RFI #: 79  
 Date: 3/16/2012  
 Job: EB-02 Keller Springs Lofts  
 Phone: 877-777-5115

CC: Jordan & Skala Engineers, Inc. (Dallas)  
 Subject: Penetrations in structural beams

RFI #: 84  
 Date: 3/23/2012  
 Job: EB-02 Keller Springs Lofts  
 Phone: 877-777-5115

RFI #: 72  
 Date: 3/8/2012  
 Job: EB-02 Keller Springs Lofts  
 Phone: 877-777-5115

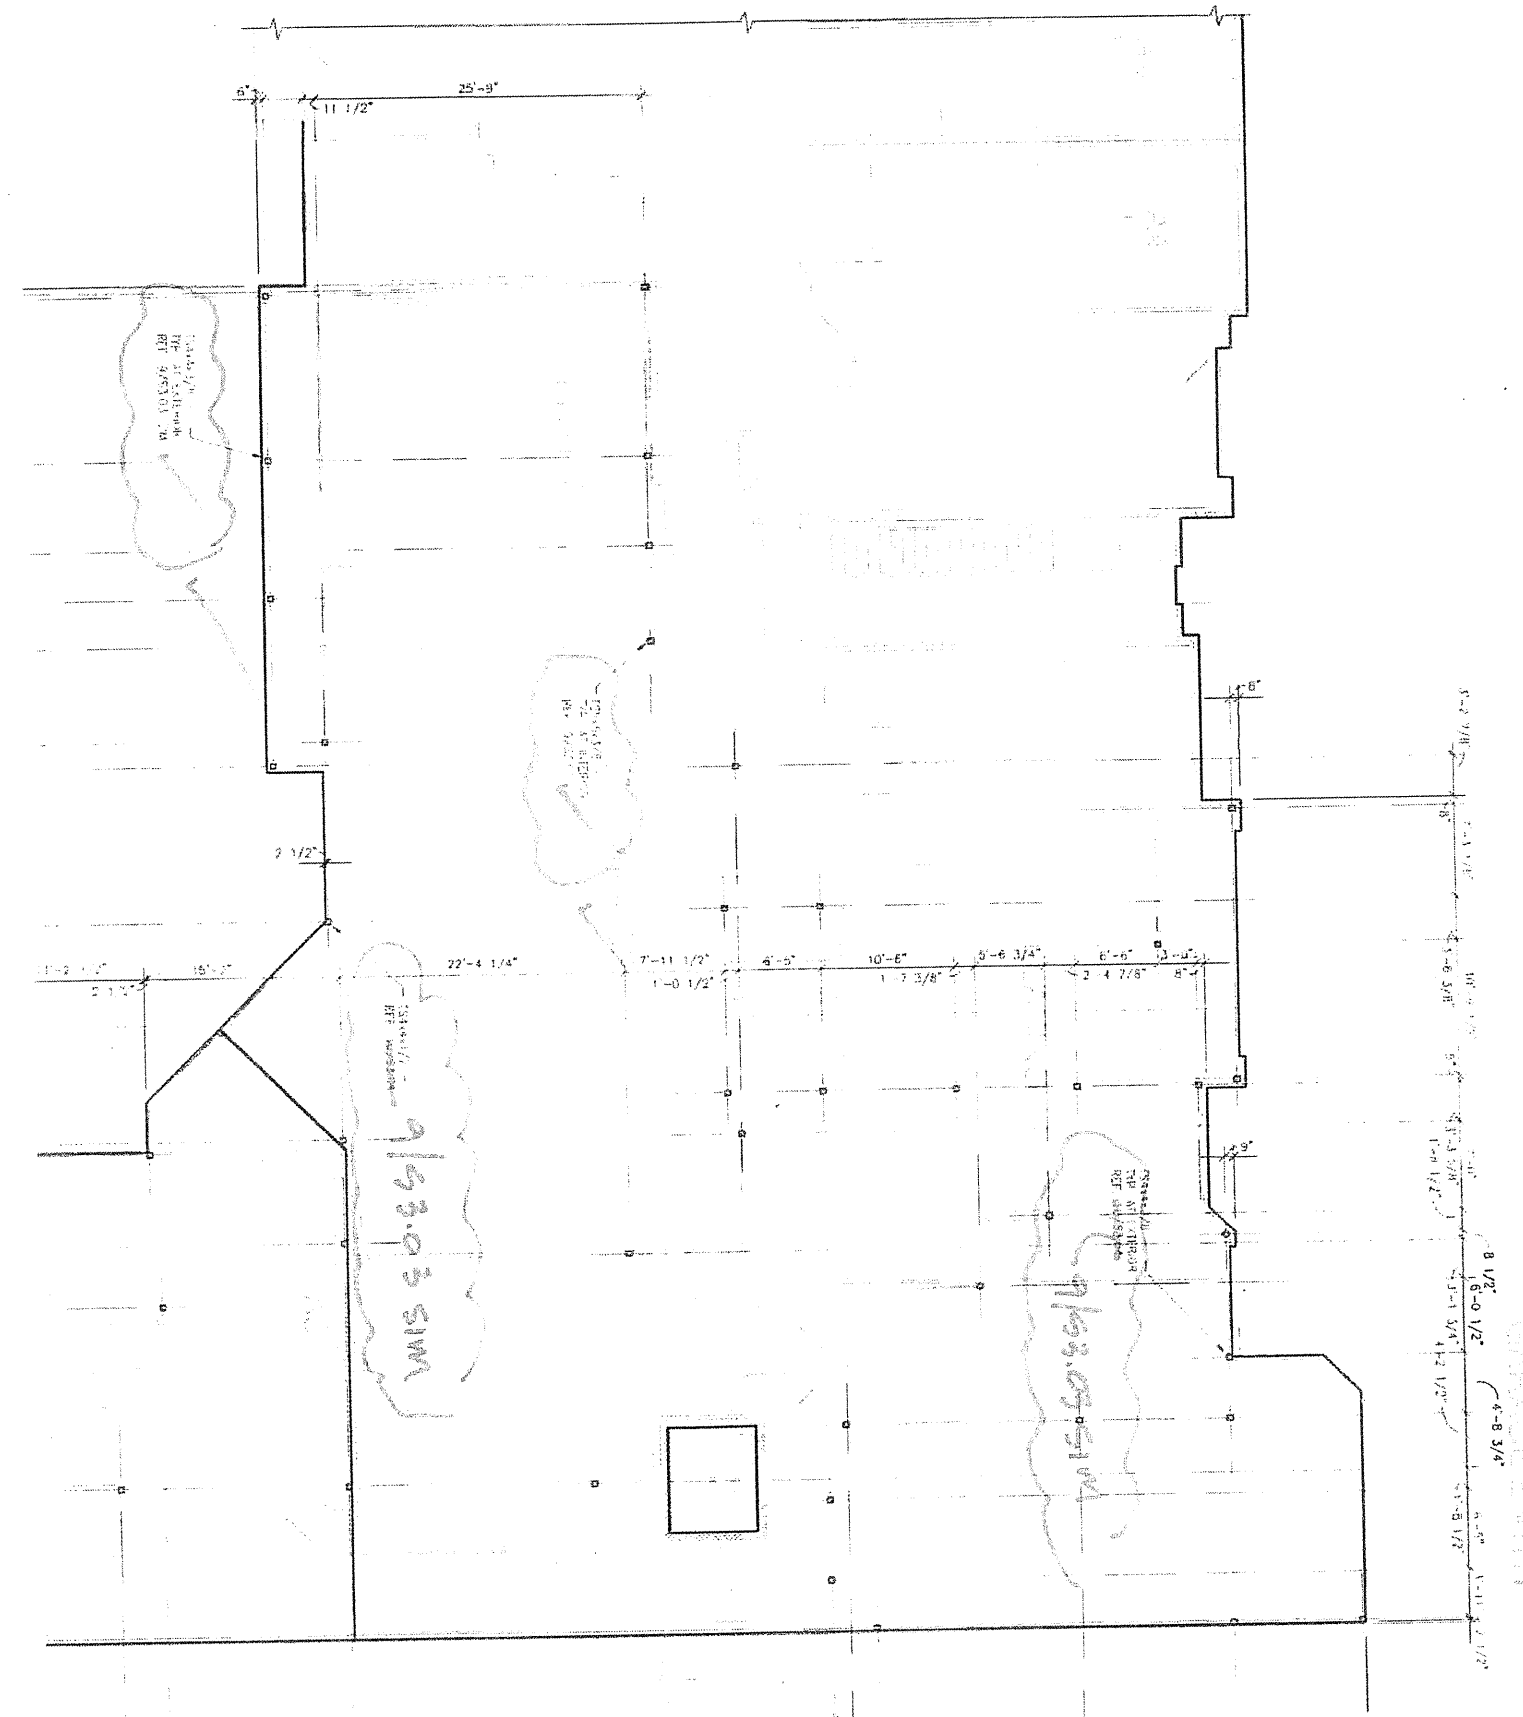
Request: Date Required: 3/22/2012  
 After reviewing the answer to RFI 72 and speaking with our plumber and you in your office today, we would like to propose using 1/2" carpet pad wrapped around any piping through beams as an alternative to installing sleeves as suggested.

Response:  
 PPO takes no exception structurally. Please verify that this solution is acceptable with the Plumbing Engineer.  
 R. Trent Perkins, PE  
 Parkin-Perkins-Olsen Consulting Engineering, Inc. March 21, 2012

SECTION  
 NO SCALE

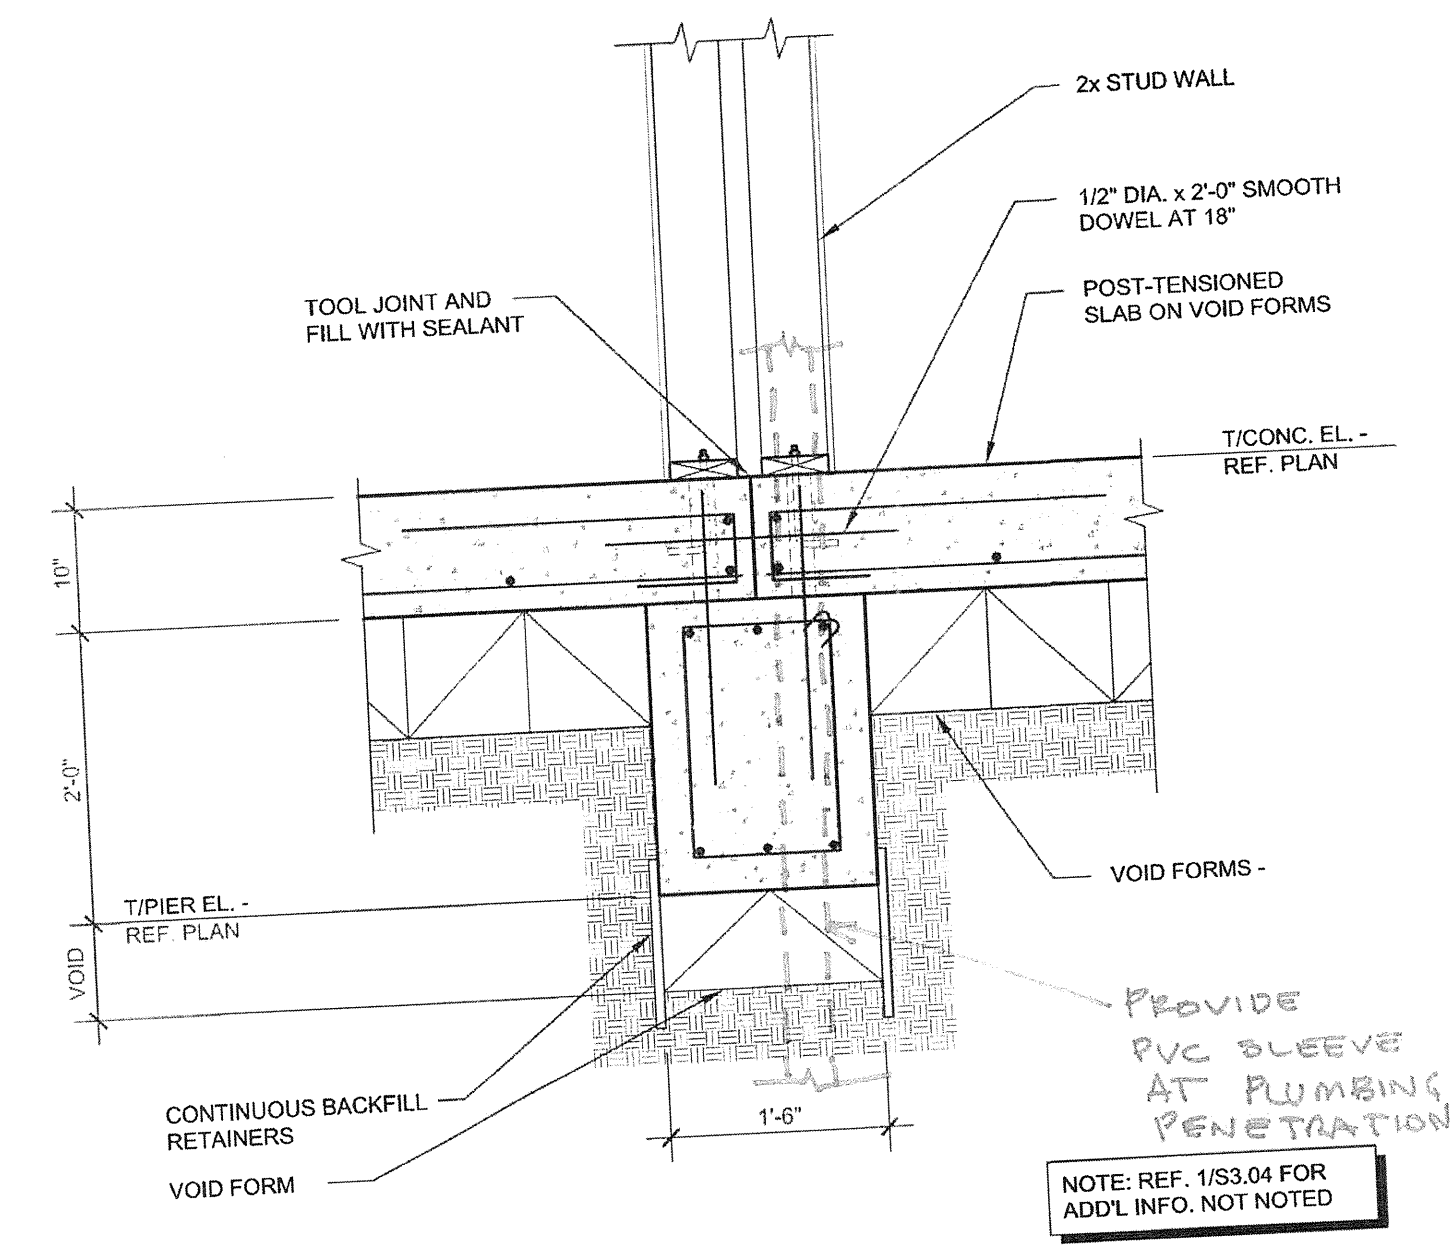
Request: Date Required: 3/13/2012  
 Please provide the appropriate details and procedures for the placement of plumbing pipes in the structural beam locations shown on the included attachment. The beams that are marked on the attachment will all have plumbing stacks located in them, as the beam is located under a party wall in which plumbing is located

Response:  
 See attached detail for penetrations.  
 R. Trent Perkins, PE  
 Principal March 13, 2012

NOTE:  
 1. PROVIDE ADD'L REINFR PER 4/S3.01  
 2. DIAMETER OF SLEEVE SHALL BE 1/2" LARGER THAN PIPE MINIMUM.
